Planning Officer's Report – LDCA DECEMBER 2024

APPLICATION	2024/51 – Balcony & Verandah at the Yacht Club with Secondary Means of Escape
PERMISSION SOUGHT	Full Permission
REGISTERED	9 th October 2024
APPLICANT	St Helena Yacht Club
PARCEL	JT010021 & JT010001
LOCALITY	St Helena Yacht Club, the Wharf
ZONE	Intermediate
CONSERVATION AREA	Heritage Coast
CURRENT USE	Yacht Club
PUBLICITY	The application was advertised as follows: <ul style="list-style-type: none">▪ Independent Newspaper on 11th October 2024▪ A site notice displayed in accordance with Regulations.
EXPIRY	25 th October 2024
REPRESENTATIONS	One Received
DECISION ROUTE	Delegated / LDCA / EXCO

Diagram 2: Proposed Floor Layout

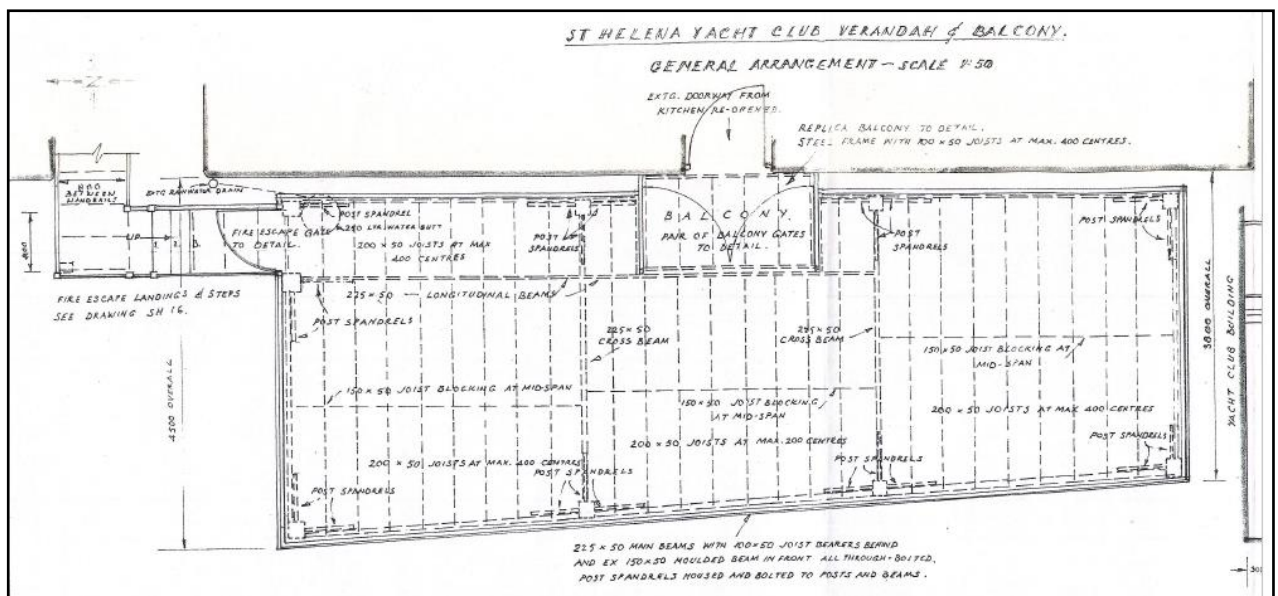
In relation to the previously approved scheme (2022/83), while the balcony would not be amended, the applicant proposes that the verandah has a maximum depth of 4.5m (an increase over the approved verandah of 0.75m to incorporate a clear access to a proposed means of escape, see below) at one end (north) which would taper to a maximum 3.8m depth at the southern end. The length of the verandah will remain as previously approved at 11m (albeit that from the sea – west, clear views of the extension of the proposed means of escape would be visible adding to the overall length) .

It is not clear why any balcony should align itself with features relating to a road which may change, possibly in the near future. However in order to retain the same amount of floorspace (or as near as possible) on the verandah while providing a new, clearly-marked access to the means of escape, a widened section of verandah at the northern end would help to meet this new requirement while retaining the standing/seating area as originally envisaged.

The purpose of Condition 10 attached to the previous development permission was to restrict the verandah to upto 3.8m away from the building as part of the structure could otherwise be over the roadway. Condition 9 was attached to ensure pedestrian access at road level was maintained when tables and chairs were positioned outside the building on the ground floor such that access 1.2m wide was maintained and unobstructed for pedestrians, including wheelchair users.

As there is almost a 2.7m width of clear space between the two posts on the northern section of the proposed development and more than 1.2m to the south between posts, this can be accommodated. A suitable condition will be attached to ensure that the proposal allows unobstructed public access underneath the proposed balcony/verandah.

Diagram 6: Layout & Elevation of Fire Escape

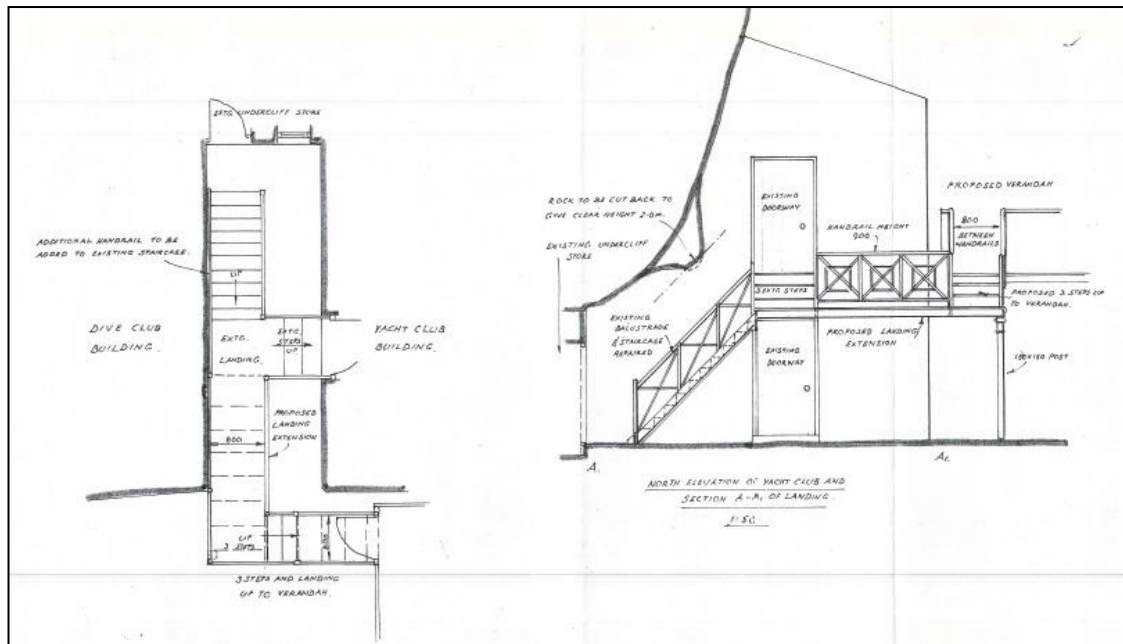
The applicant's submission indicates that their agent "met the Fire Officer at the building on 28th September and the scheme was agreed subject to notes being added to the drawings (a) stating a minimum width of 800mm for the proposed steps and landing extension, (b) a handrail height on the landing of 1m, (c) the addition of a second handrail to the existing staircase (on the Dive Club side) and (d) the creation of minimum headroom above the staircase pitch-line of 2m, by cutting back a small projecting piece of the overhanging rock." The proposal also includes the removal of some overhanging rock (see Diagram 6 below).

Following the previous approval in 2023 of a balcony and verandah, in line with the Fire Officer's recommendations, the current proposal now includes a means of escape from the verandah. The proposed escape steps/landing will, like the verandah to which it will be attached, not be attached directly to the Listed Building but to an existing escape external stairs to the side of the Yacht Club. The style of the balustrading to the means of escape will be similar to that of the proposed balcony/verandah and emulate that of the deck – in criss/cross style. The proposed means of escape will be located close to the Dive Club building (Grade III Listed) and appear as a protrusion when viewed from the north; however given it will only extend forward by 1.2m which is significantly less than the proposed 4.5m depth of the proposed Verandah, it is considered that, of itself, its appearance will not adversely impact on the character or appearance of the neighbouring or host Listed Building, or the setting of the Conservation Area.
